UNITED STATES PATENT AND TRADEMARK OFFICE

Office Action Summary	Application No.	Applicant(s)	
	10/797,255	ROARTY, BRIAN P.	
	Examiner	Art Unit	
	Erin M. Boyd	3663

DETAILED ACTION

Gray French; Figure 1, page 67

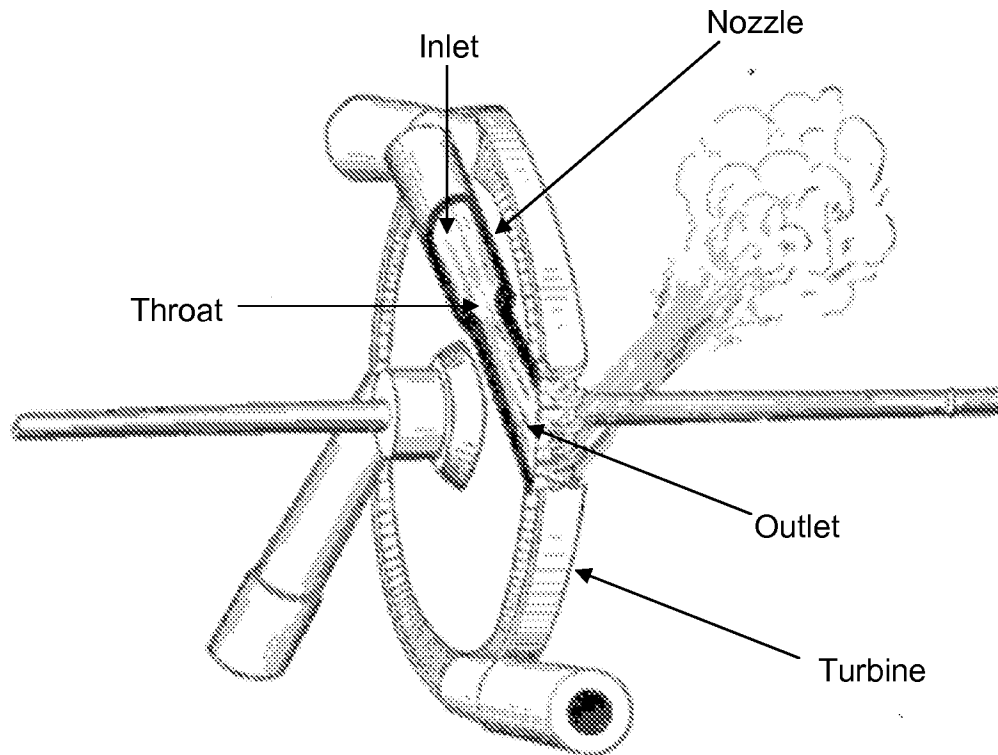
18. Regarding Claim 4, Gray French teaches a system comprising a nozzle having an inlet, a throat, and an exhaust (see figure below); a fluid flowing through the nozzle; and a means (i.e. turbine) for transforming the flow from the exhaust into work outside the system. Gray French fails to teach a means embedded within the nozzle for transferring energy into and heating the nozzle, thereby indirectly transferring energy into and heating the fluid and inducing a phase change in the fluid. Patterson teaches a means 38/44/36 embedded within a nozzle 12 for transferring energy into and heating the nozzle 12 (column 2, lines 15-17); thereby indirectly (through means 36) transferring energy into and heating the fluid and inducing a phase change in the fluid (column 3, lines 59-60).

19. Regarding Claim 5, Gray French teaches a system wherein the cross-sectional interior volume of the inlet, throat, and exhaust of the nozzle vary only across one plane perpendicular to the axis of the fluid flowing through the nozzle (see figure below).
